ADDENDUM NO. 1

PROJECT NAME: Atlas Ranch Elementary

CLIENT NAME: Jarrell ISD

ADDENDUM DATE: November 3, 2026

1 CODE ANALYSIS PLAN - LEVEL 2
1/16" = 1'-0"

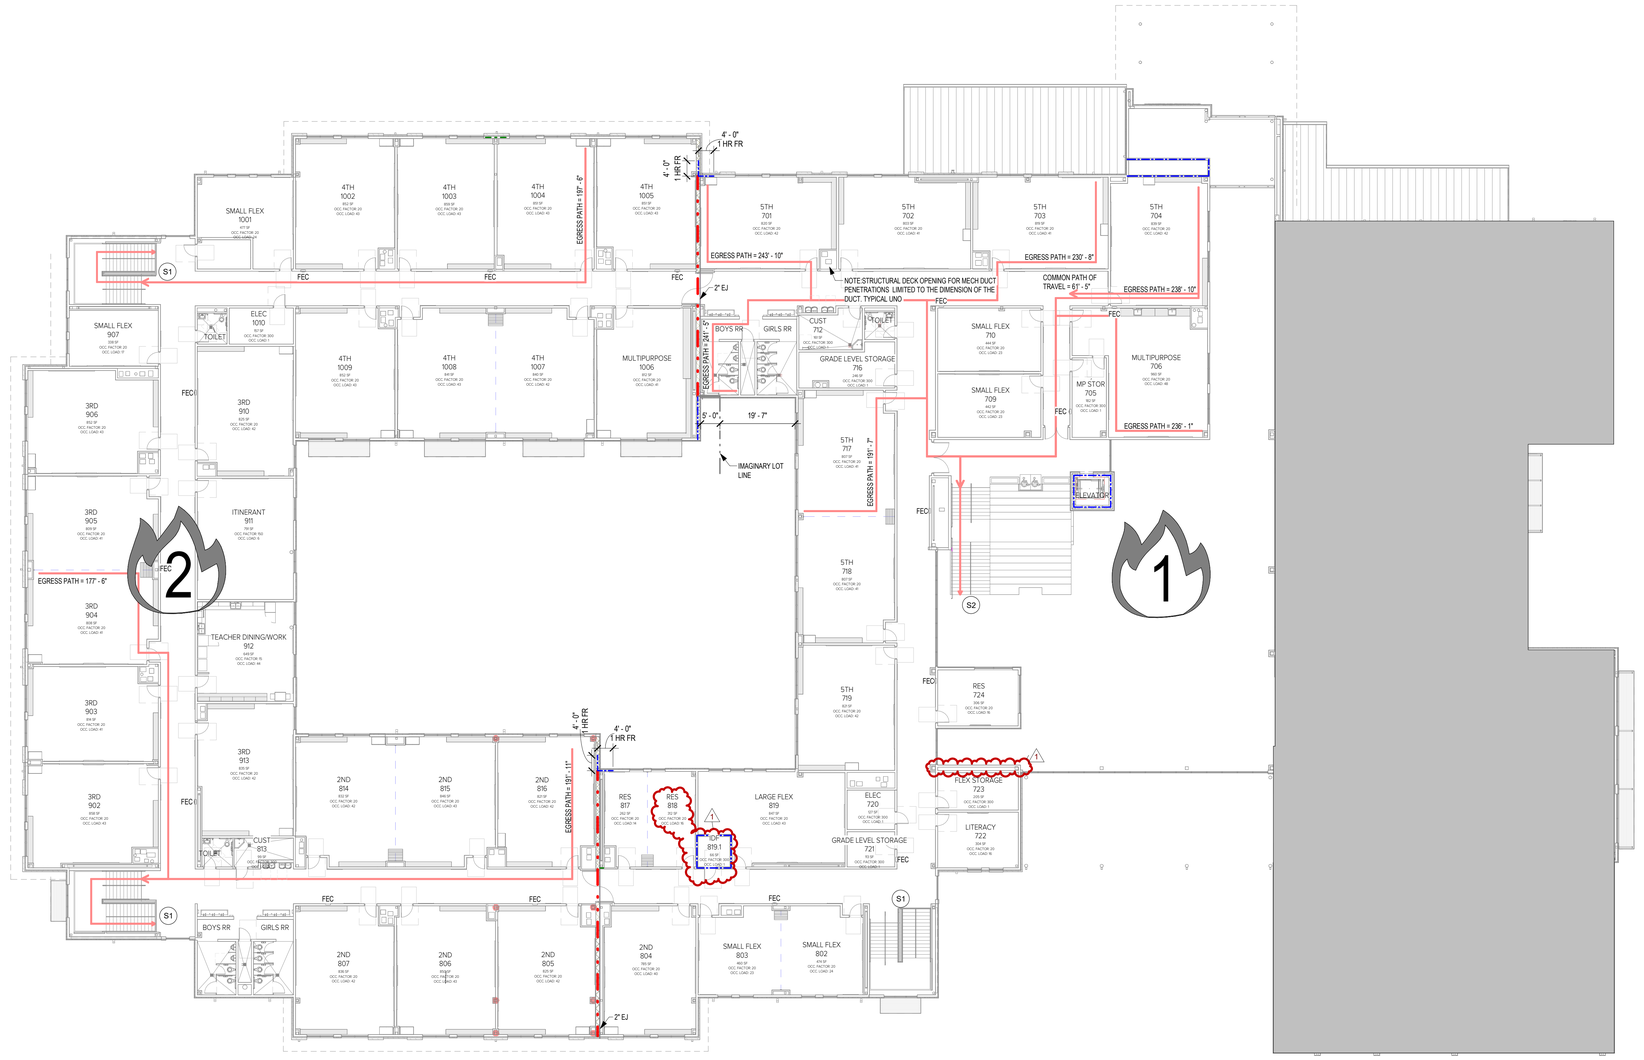
AD No 1, ARCH Item 9: **To the Drawings, Sheet G2.02 "CODE ANALYSIS PLAN – LEVEL 2"**

2 MASTER PLAN - LEVEL 2 - FIREPROOFING PLAN
3/64" = 1'-0"

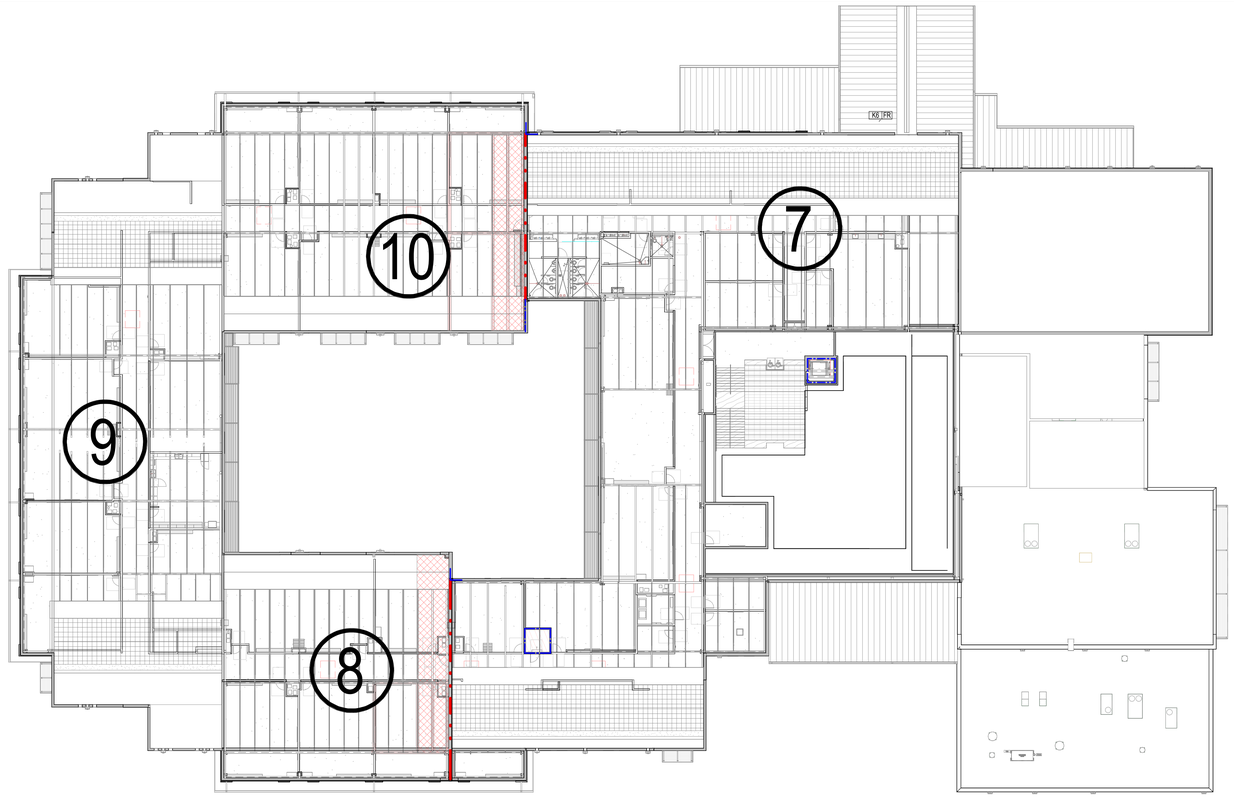
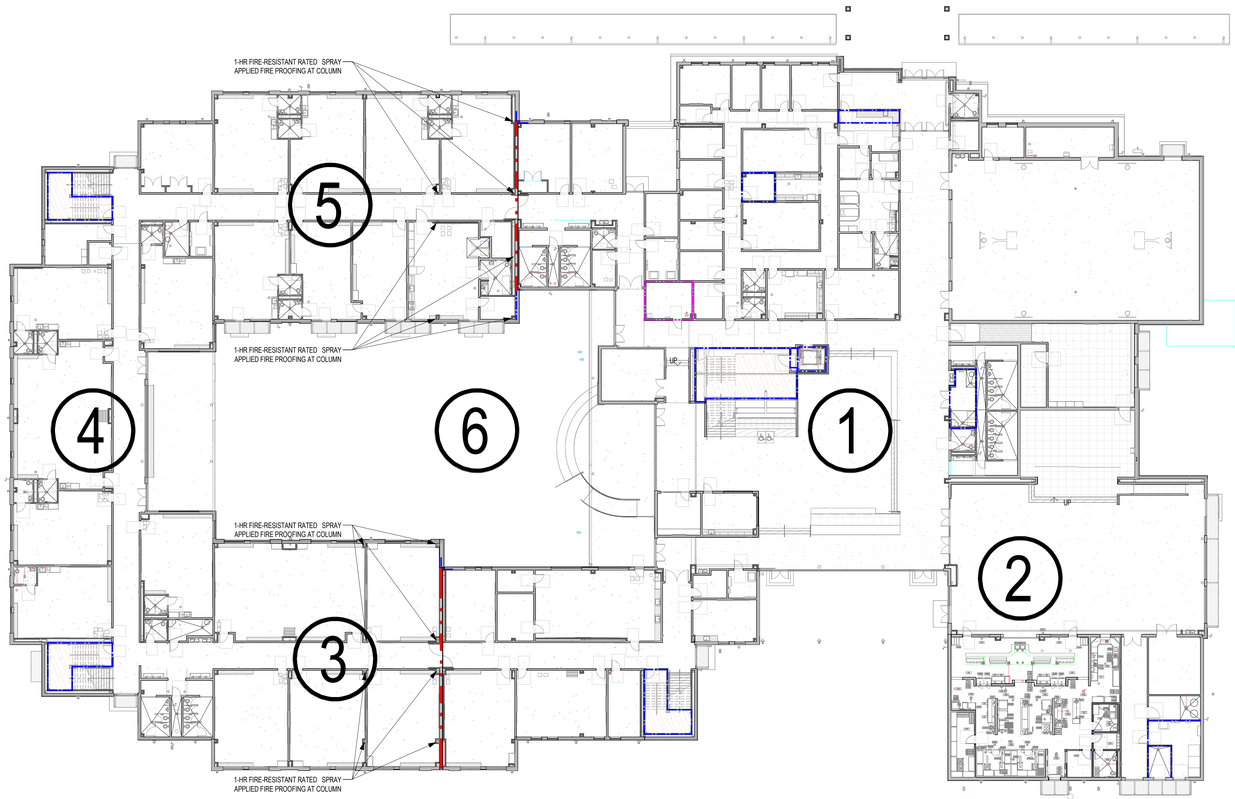
AD No 1, ARCH Item 10: **To the Drawings, Sheet No. G2.03 "FIRE PROOOFING PLAN"**

Job No.: 1836-12155 (W0HC-0401)
Sheet No.: C1.01
Drawn By: MRC
Date: 11/05/2026
S&S

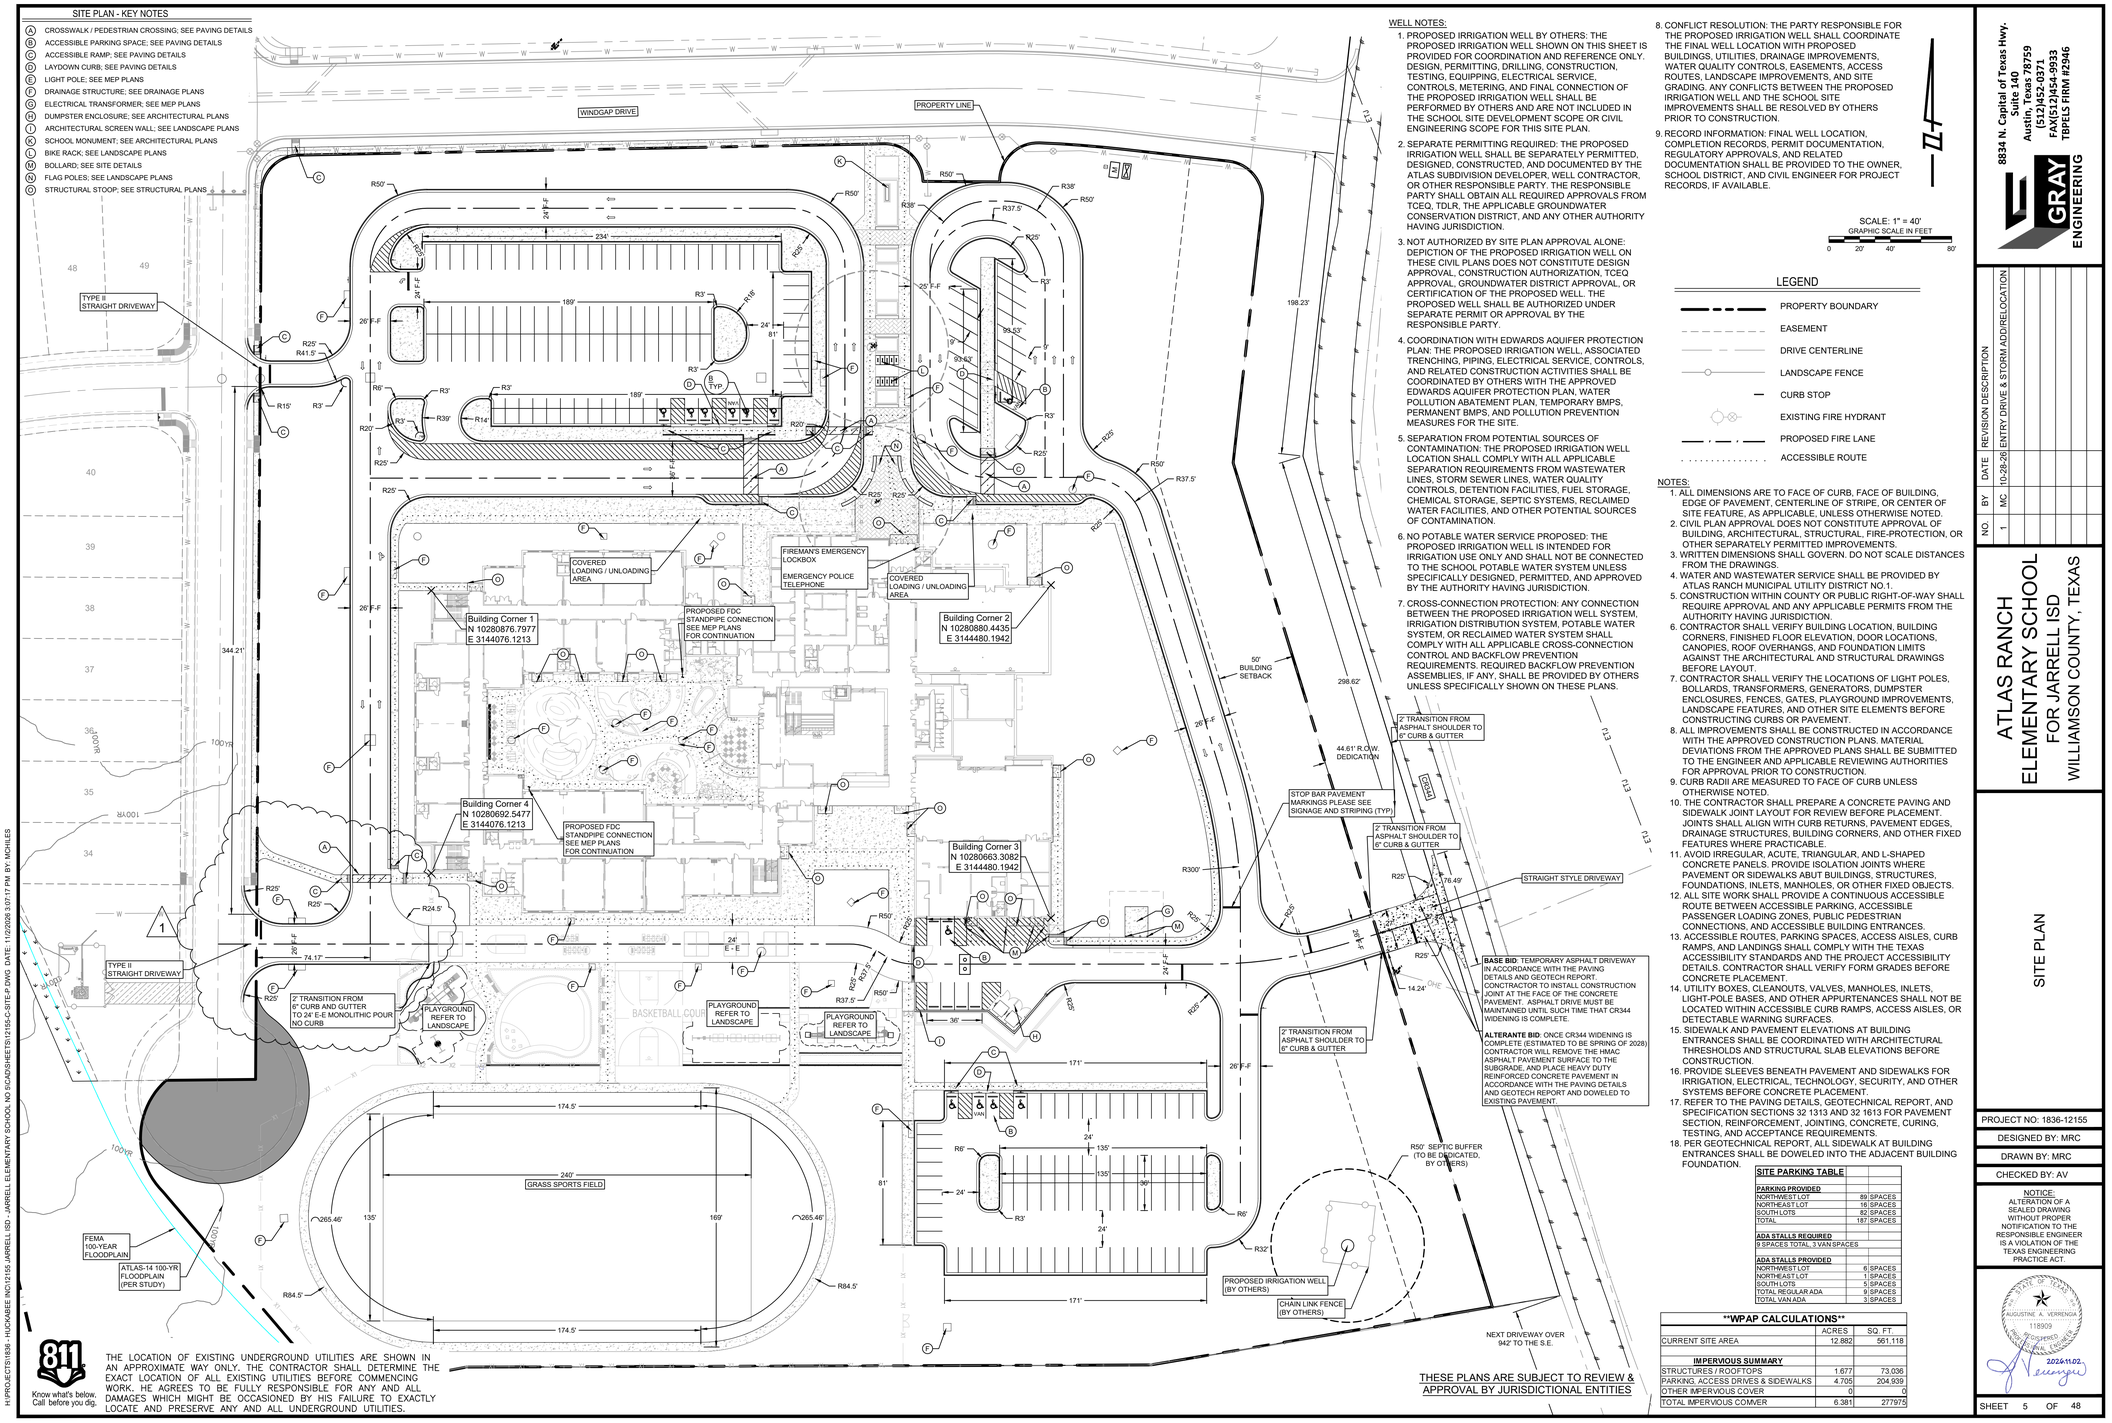
AD No 1, CIVIL Item 6: **To the Drawings, Sheet C1.01 "EROSION AND SEDIMENTATION CONTROL PLAN"**
1) Updates to southwestern driveway, updates to southeastern storm sewer.

H:\PROJECTS\1836 - HUCKABEE INC\12155 JARRELL ISD - JARRELL ELEMENTARY SCHOOL NO 9\CAD\SHEETS\12155-CPAVE.DWG DATE: 11/2/2026 3:07:38 PM BY: MCHILES

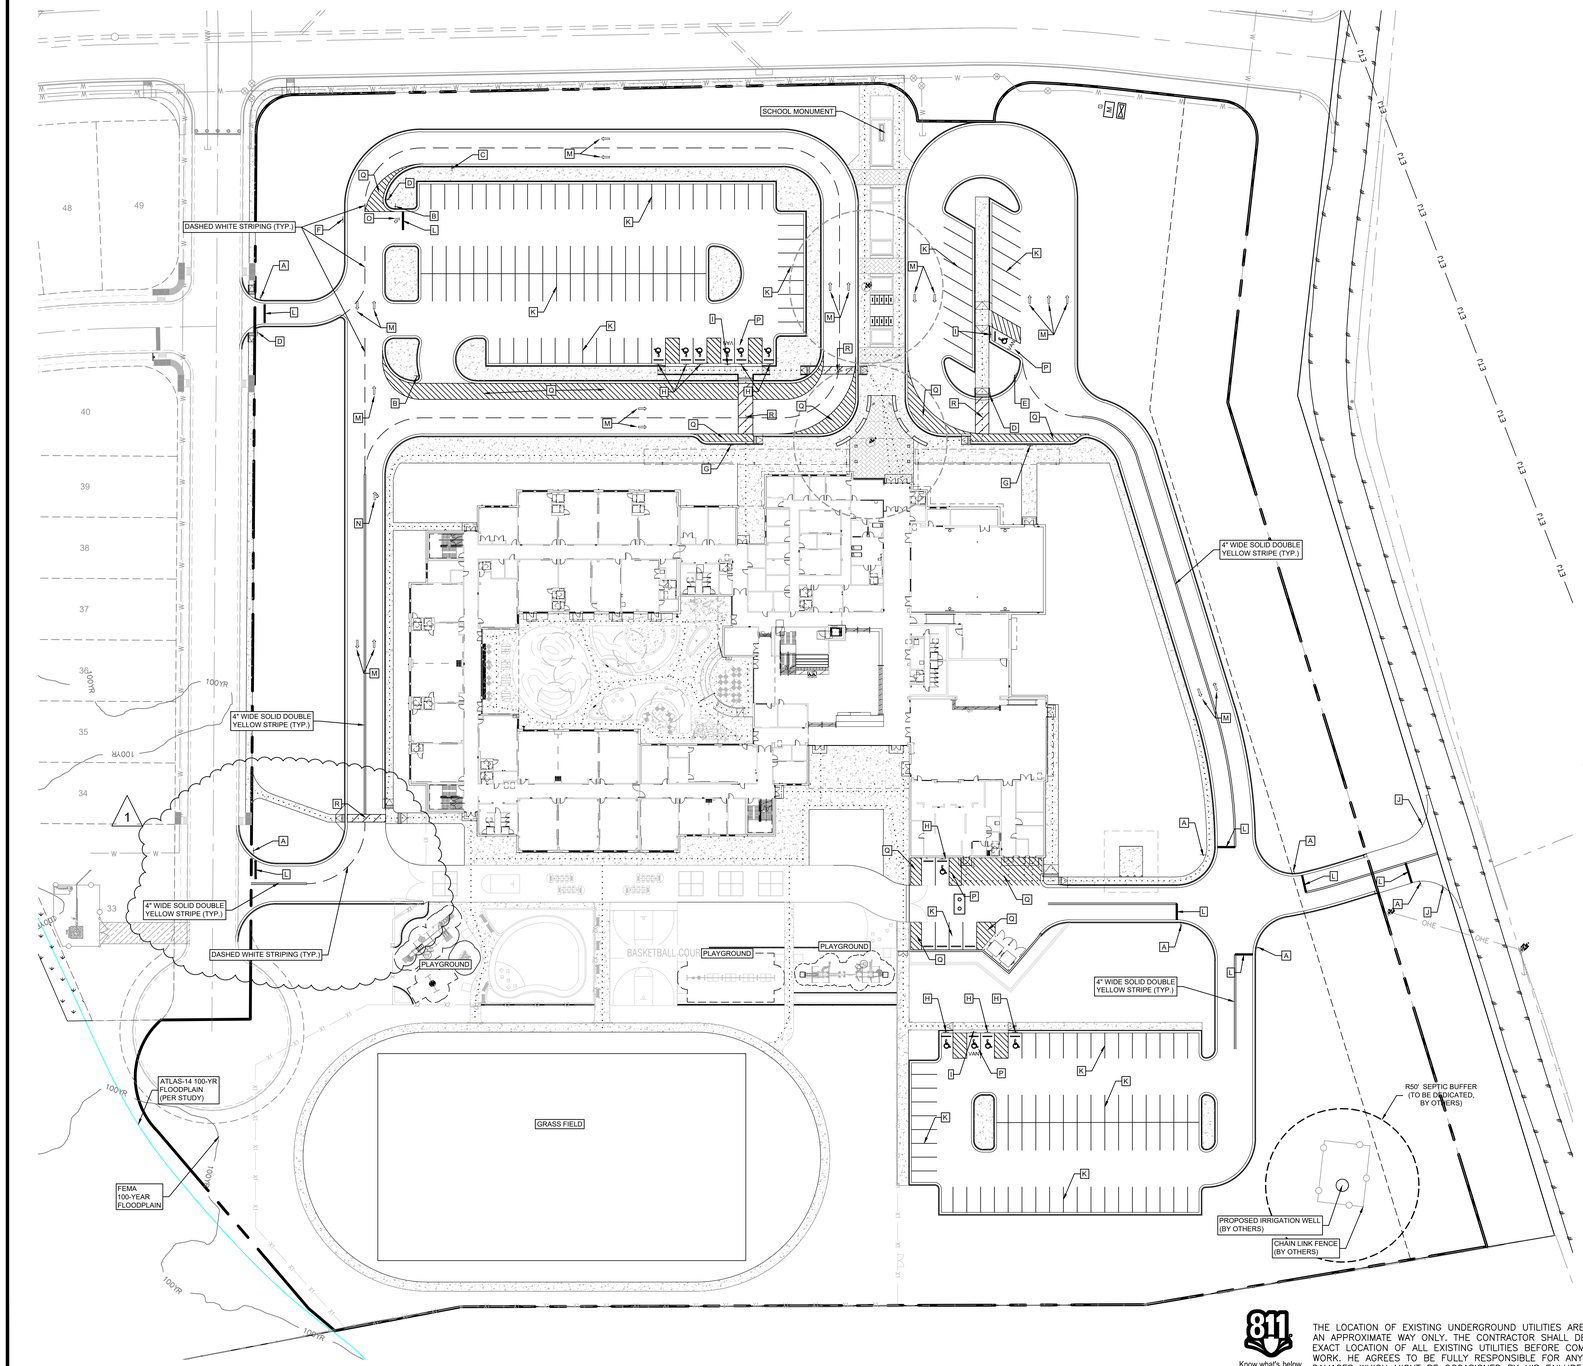
AD No 1, CIVIL Item 8: **To the Drawings, Sheet CS.02 "PAVING PLAN"**
1) Updates to southwestern driveway.

STORM LINE B1 1+00 - 4+00
& LAT B1.5, B1.6

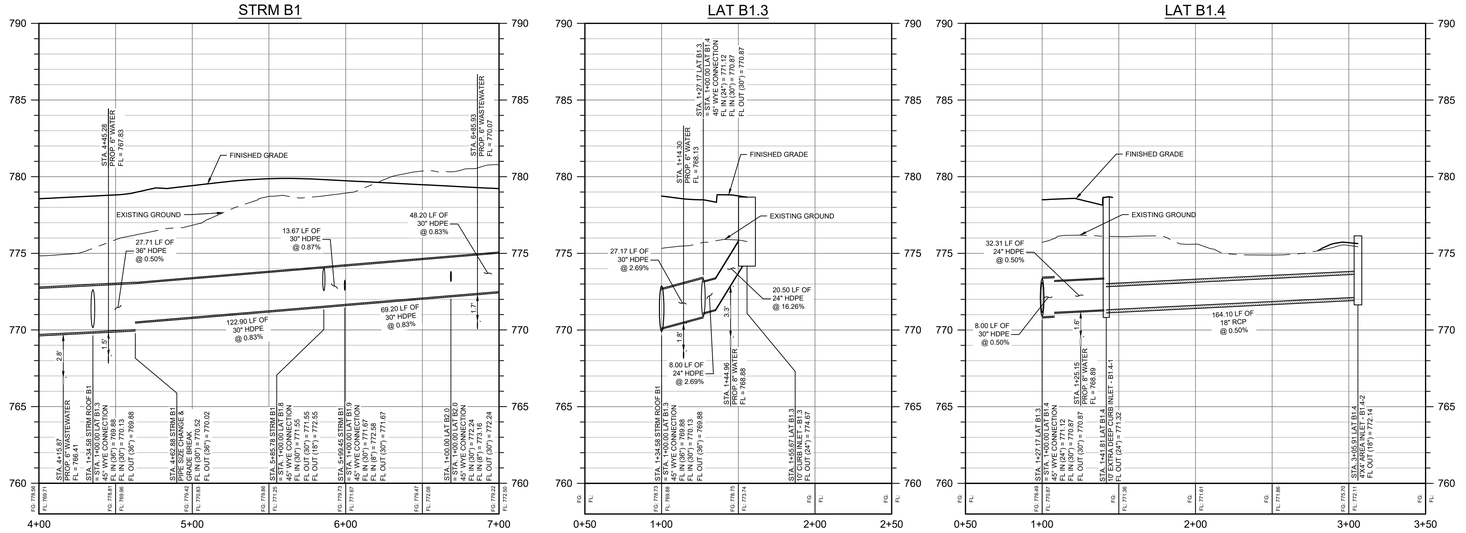
AD No 1, CIVIL Item 18: **To the Drawings, Sheet CU.03 "STORM LINE B1 1+00 – 4+00 & LAT B1.5, B1.6"**

Job No. 01949-04-01
Drawn By: MRC
Date: 10/08/2026
Sheet No. CU.06

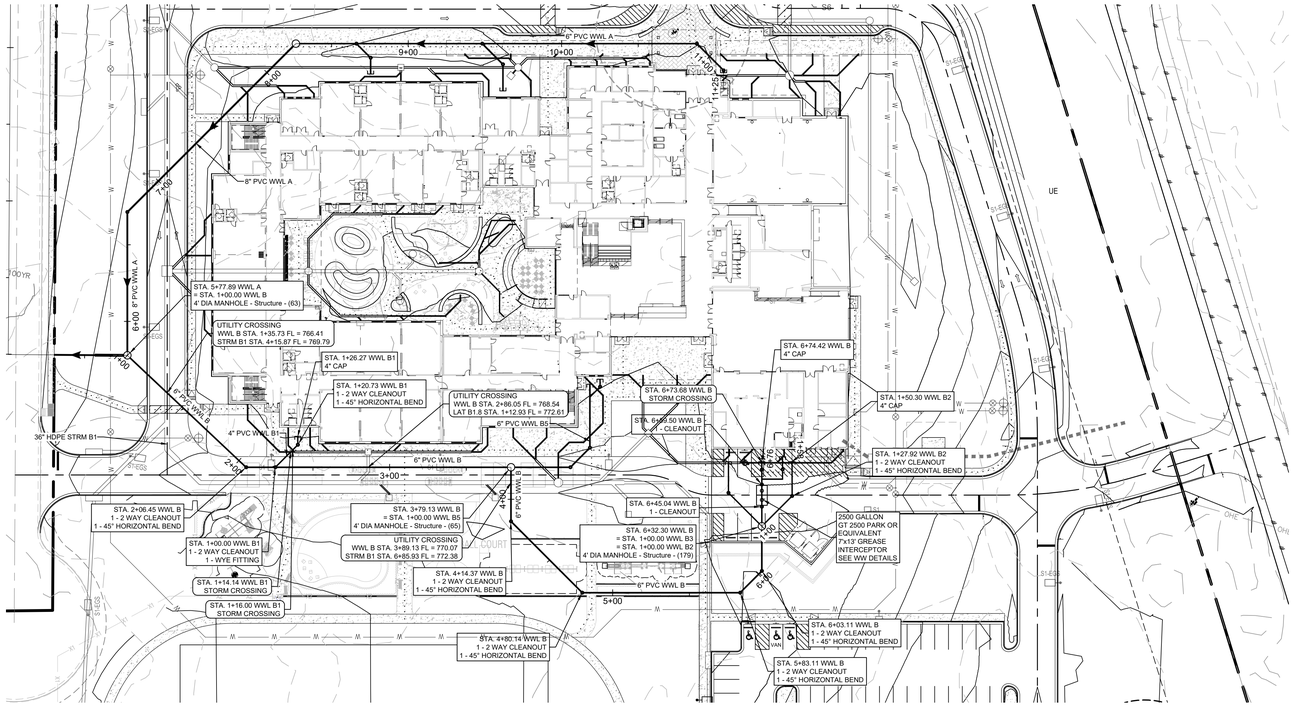
AD No 1, CIVIL Item 21: **To the Drawings, Sheet CU.06 "WASTEWATER LINE C1 1+100 – END C1.1, C1.2"**
